From: Robert Murray <robertm@ct.kanteys.co.za>
Sent: Wednesday, 08 May 2024 13:26
To: Doug Jeffery; Jamie Cloete
Cc: Nick Holland; admin@bm-wines.com; Darren Snyder
Subject: 16823T: Riverstone - River Rehab

We refer to our telephonic conversation earlier today related to your meeting with the Dept of Env Affairs and their query related to the impact that the works would have downstream of Riverstone.

Floodlines prior to remediation

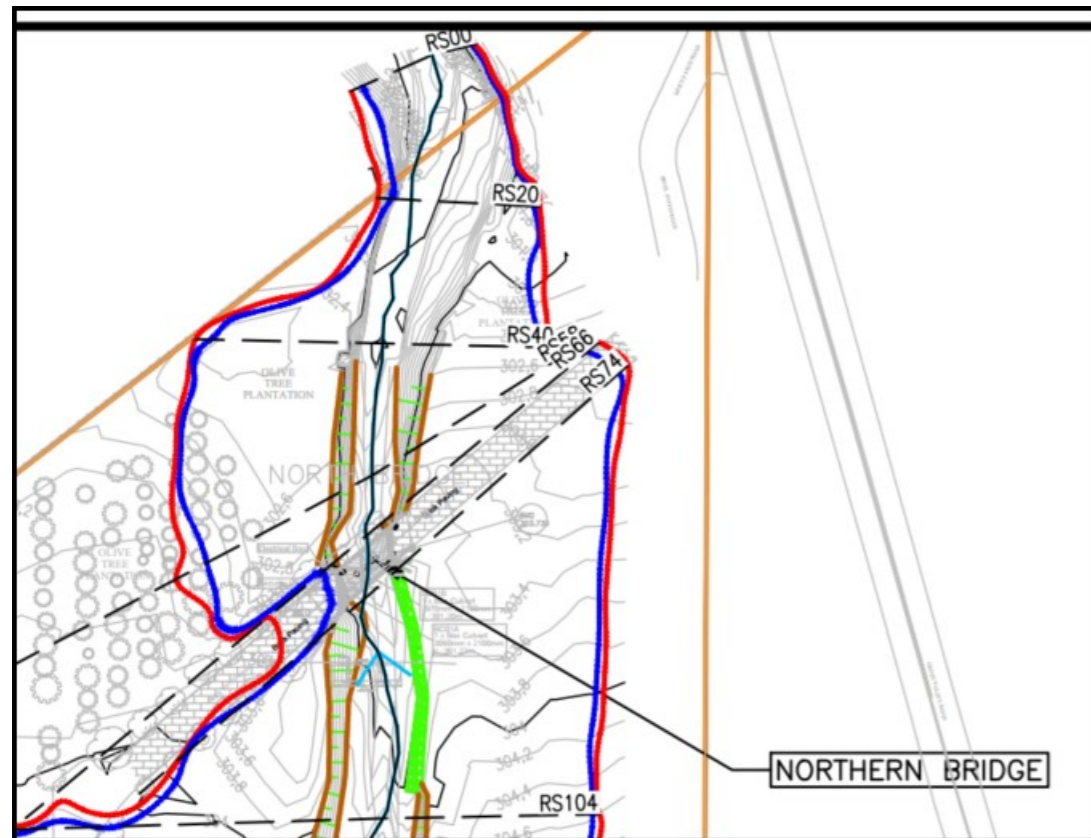
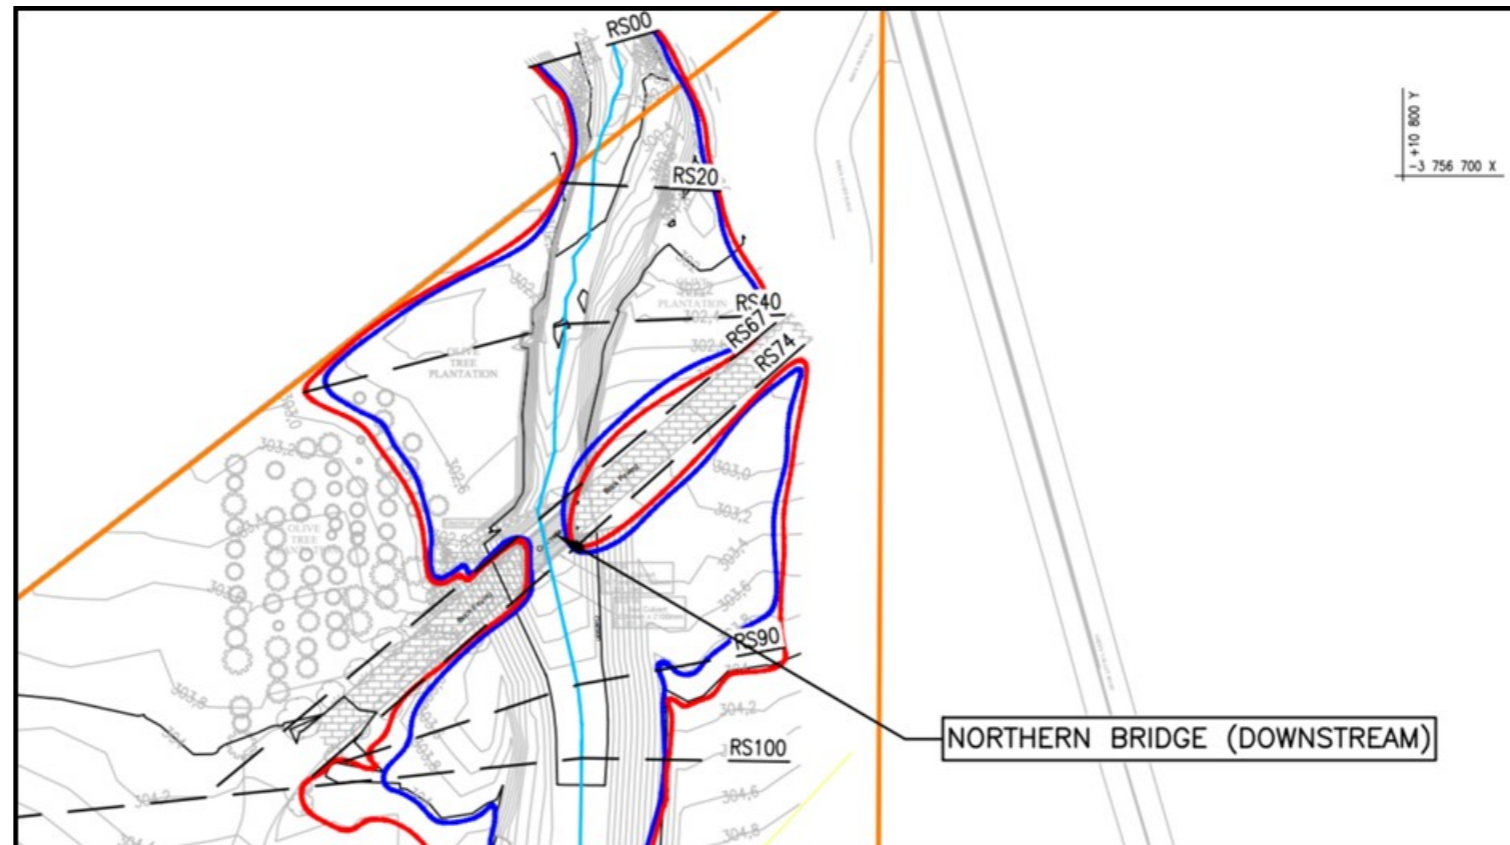
Based on our calculations the floodlines before and after the remediation are very similar, thus indicating that there is no anticipated change to the flows downstream of the remedial works in terms of flow. Over time there would however be a positive impact in so far that there should be less transportation of silt / rock downstream of the site after the remedial works have been completed and revegetated.
